PLANNING AND DEVELOPMENT SERVICES STAFF REPORT

For Planning Commission Meeting of June 7, 2016

**SUBJECT: 611 East University Street Site Plan for City Council Approval
Project No. SP16-065**

② NORTH ELEVATION
 SCALE: 1" = 20'-0"

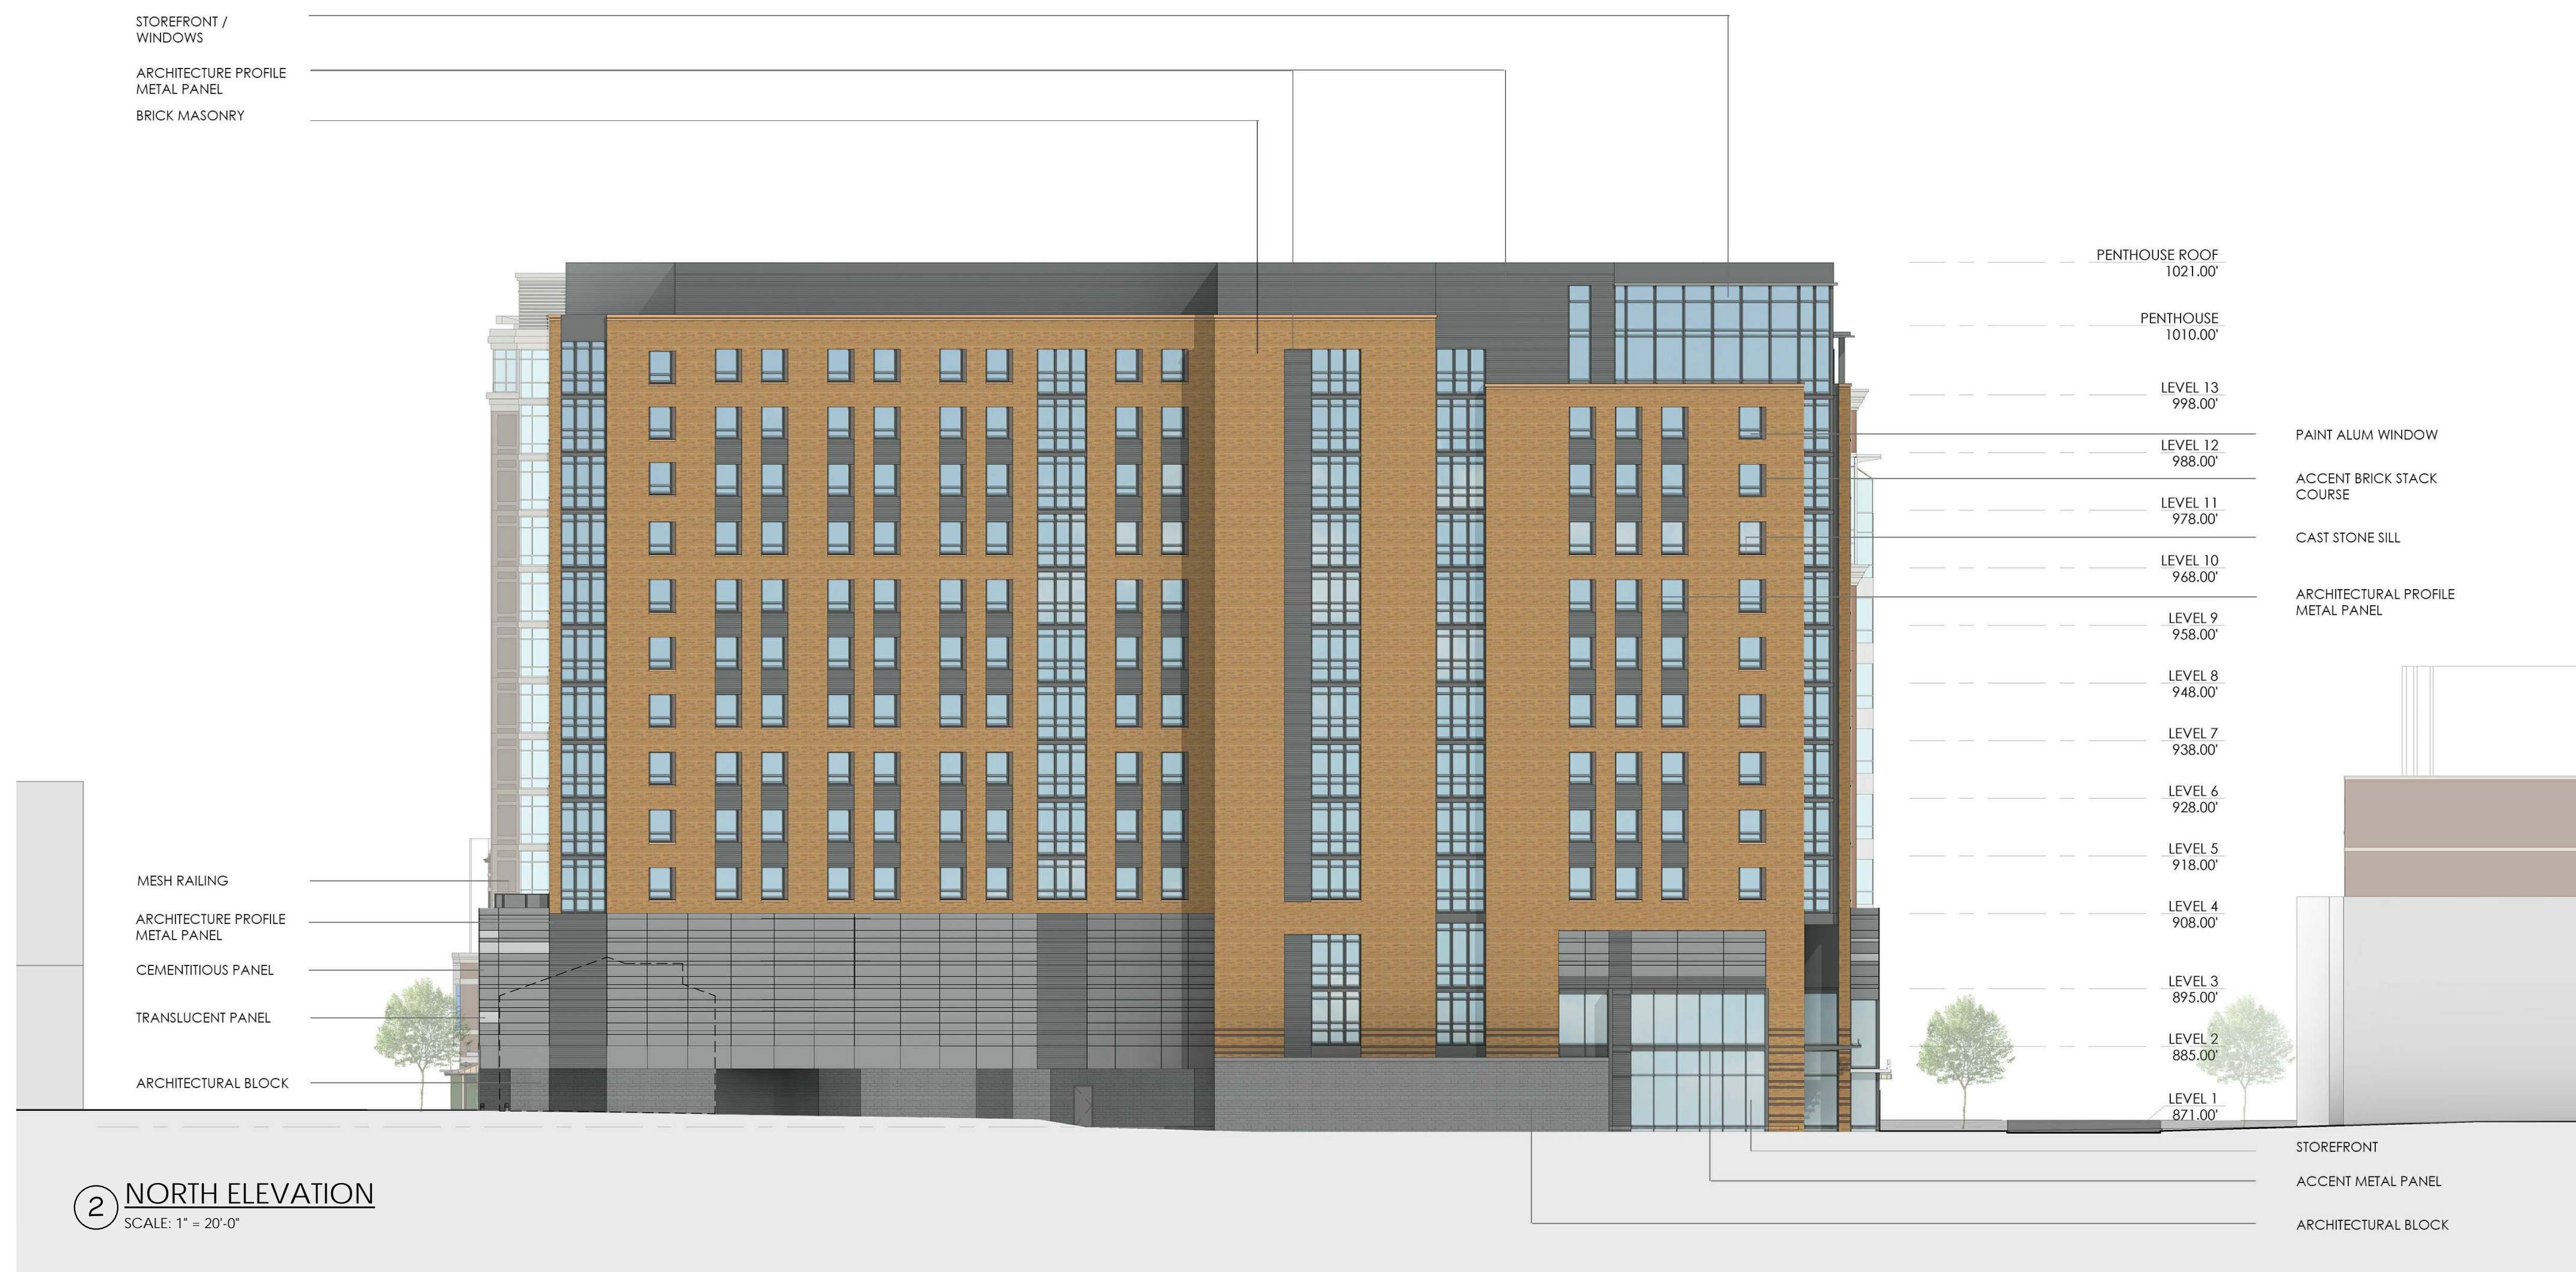
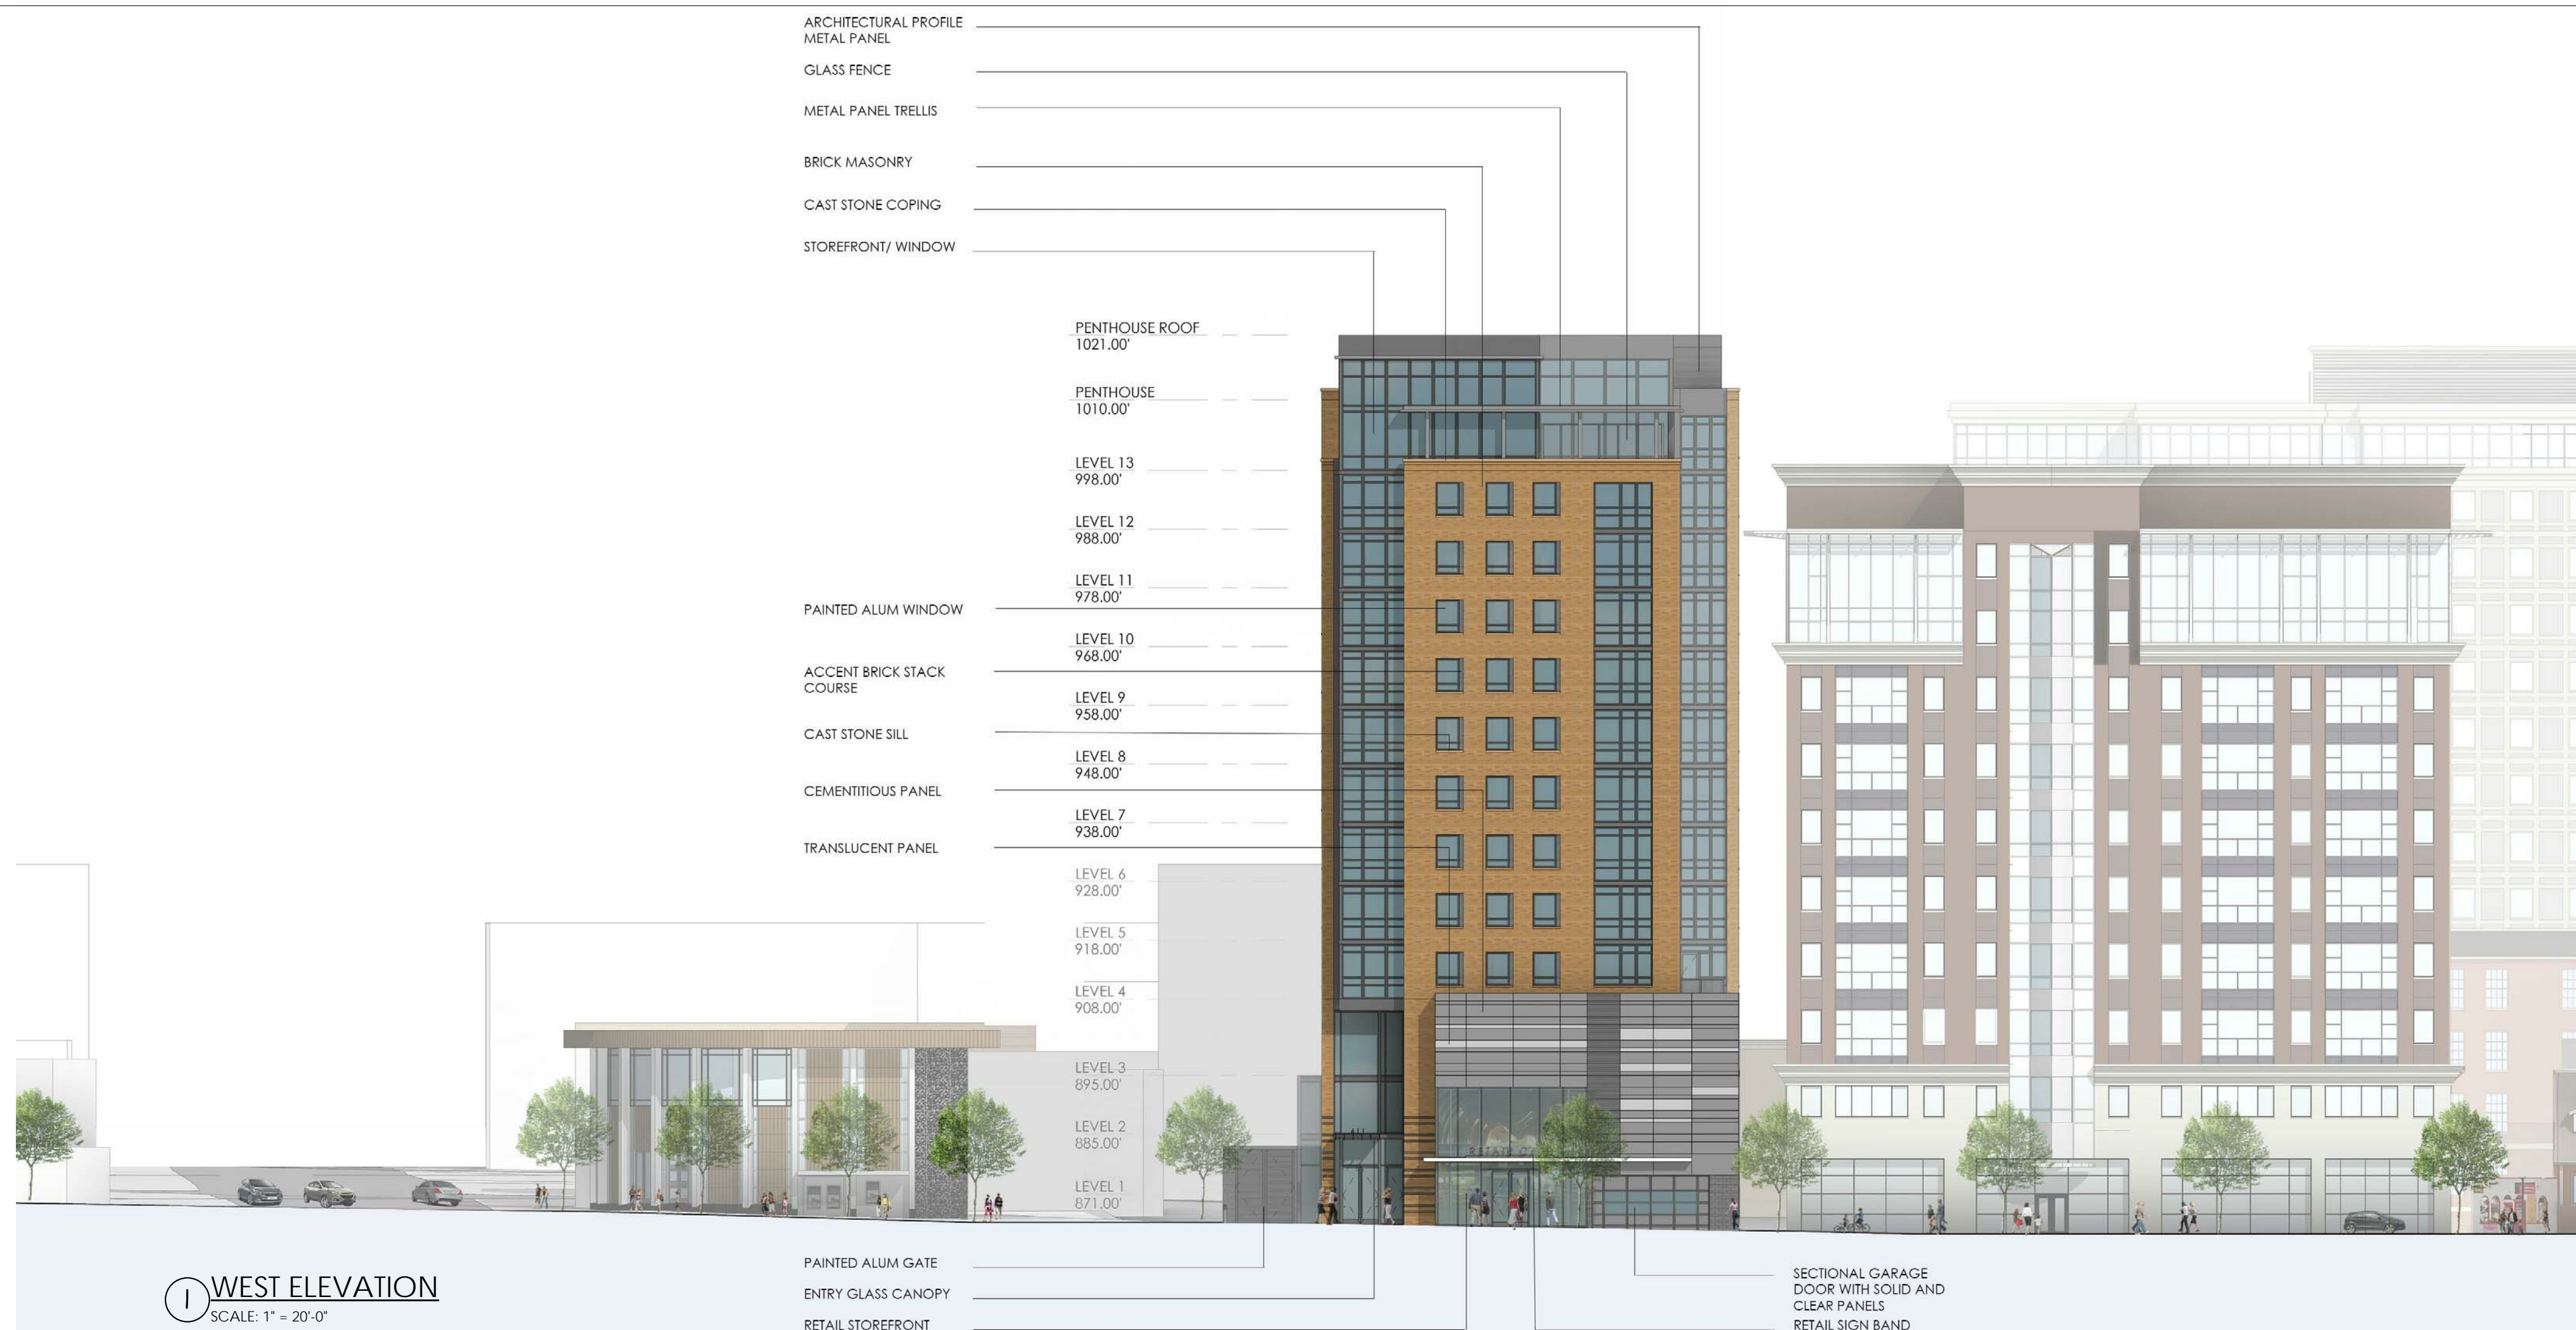
9. The building's north wall will be highly visible to South University Avenue and Central Campus. Its current design does not reflect its prominence. At present, there is nothing to modulate the 220-foot long north wall of 611 East University. As much detailing should be included on this façade, the upper half especially, as proposed on the street-facing facades. Since the proposed building will be the new background for the entire 1100 block of South University Avenue, the design team should at minimum consider adding massing articulation mimicking those existing or historical lot widths.

1. Provide more contrast on the East University façade, and make this side of the building the primary pedestrian entrance. Do not have a vehicle entrance on East University, and ensure the plaza at the northwest corner is active. Consider moveable furniture in the plaza.
2. Provide more detailing and elements that further articulate the north elevation. Consider a glass elevator on the exterior of the building, and include windows in the stairwells.
3. Create a better hierarchy between the base, middle and top of the building.
4. Consider designing different, perhaps opposing, façades on the two streets. It may be appropriate for the East University façade to be more atypical, have more color and “do something more zingy”, and the Church façade to be more conservative and conventional.

The proposed development has been revised to include stairwell windows.
